2 December 2020

Re: SSI-10051 Sydney Metro - Western Sydney Airport

ATTACHMENT A

Figure 1 - Property Affectation

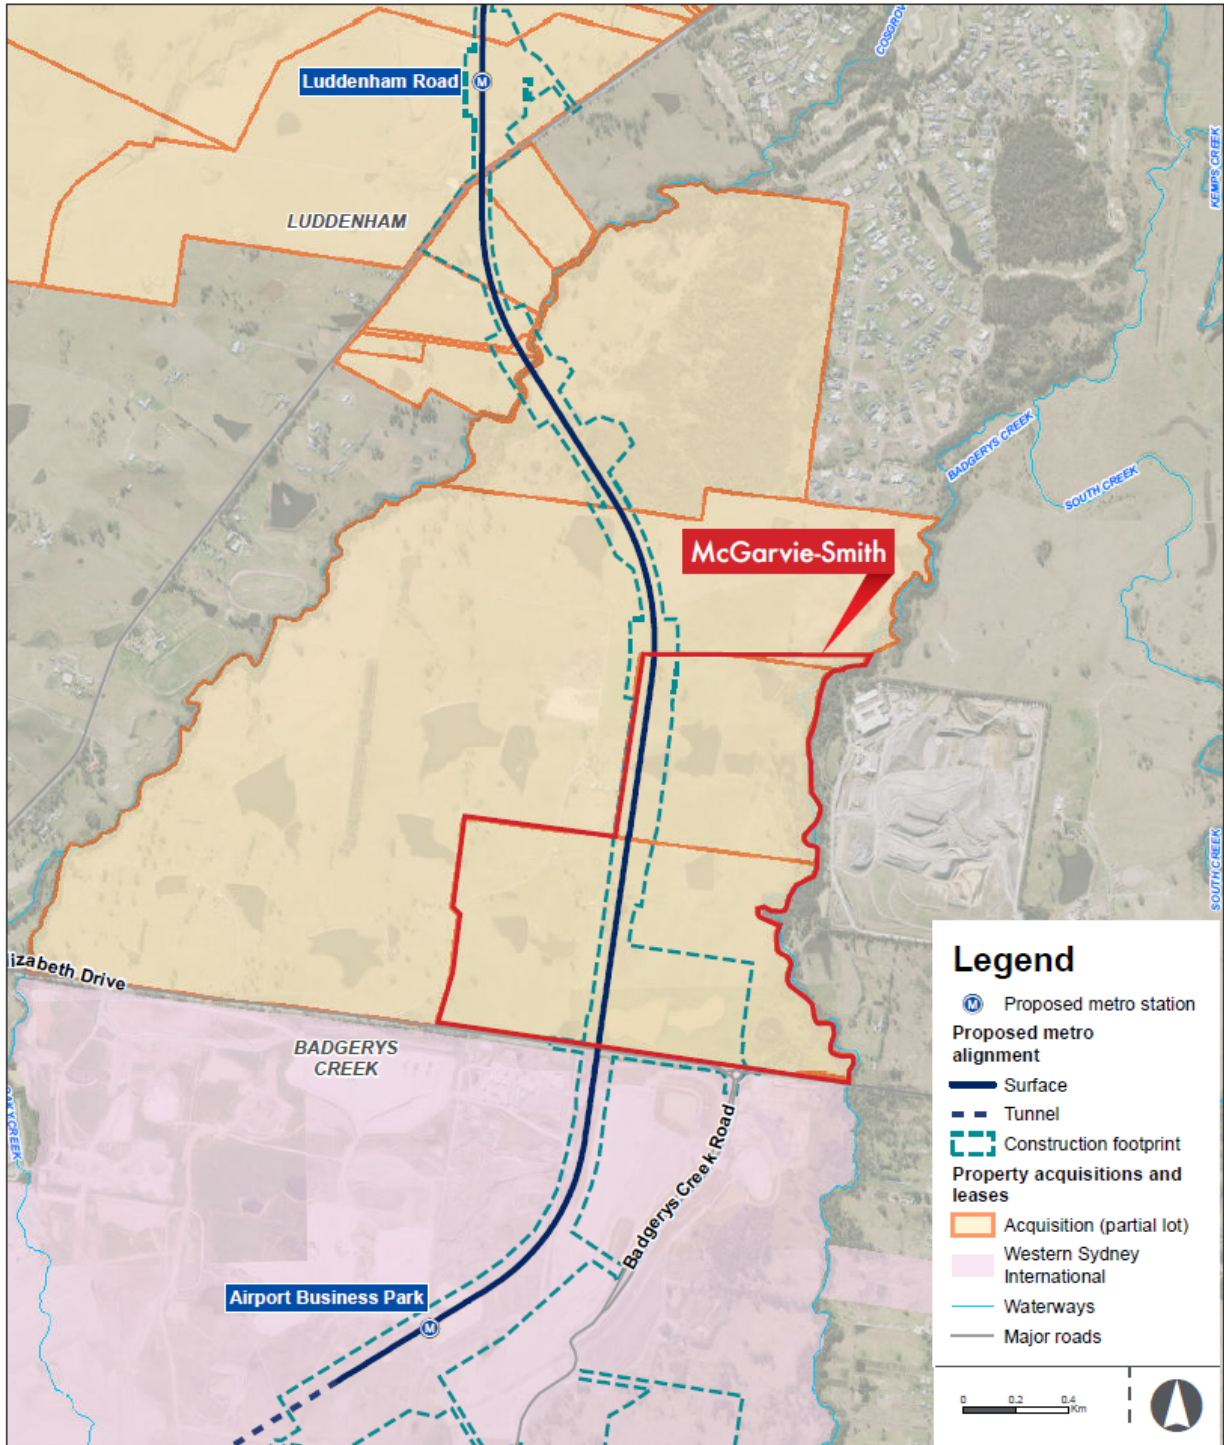
The proposed location of the property acquisitions and leases, as exhibited in the EIS, are shown in **Figure 1**. The construction footprint within the Property occupies an area of approximately 40 hectares or 25% of the Property. Figure 1 from the EIS identifies the Property as being "Acquisition (partial lot)". However, the EIS does not distinguish between "land to be acquired" and "land to be leased".

results in fragmentation of the Property and the creation of isolated pockets of land that are inaccessible. The extent of the affectation is shown in **Figure 1** and includes the following impacts:

- Access from Elizabeth Drive to the remaining part of the Property outside the construction footprint on the eastern side of the corridor is effectively denied.
- There is no access between the eastern and western parts of the property.

Figure 2 – Proposed Onsite Detention Basins and Water Quality Basins

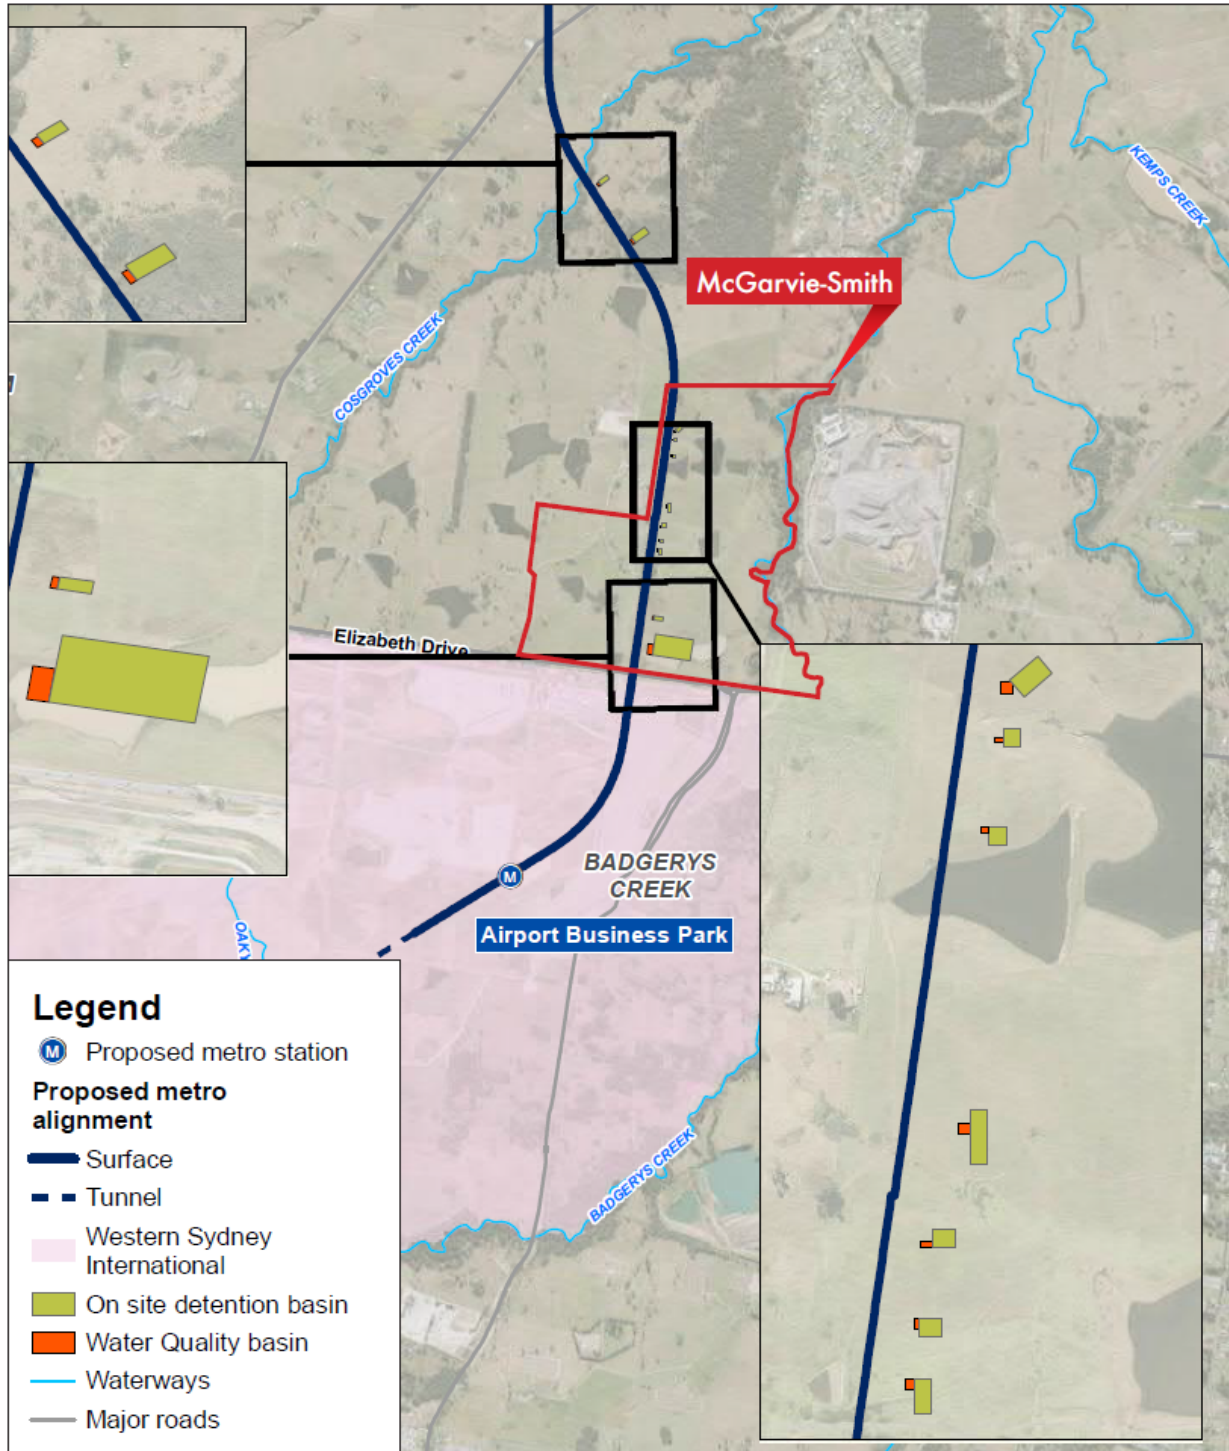
Technical Paper 6 – “Flooding, Hydrology and Water Quality” (which accompanies the EIS) identifies a number of proposed onsite detention basins and water quality basins located on the Property (see **Figure 2**).

Neither the technical paper nor the EIS provide specific details in relation to the location of the proposed on-site detention basins and water quality basins on the Property and the justification for these basins.

As indicated in **Figure 2** a significant area of the Property site is identified for on-site detention basins. Flood impact criteria are based on current land use and do not take account of the zoned land use. The need for these basins is not substantiated in the EIS and they appear excessive in size when compared to the comparable (and much smaller) basins proposed for the M12 corridor as outlined in **Figure 3**.
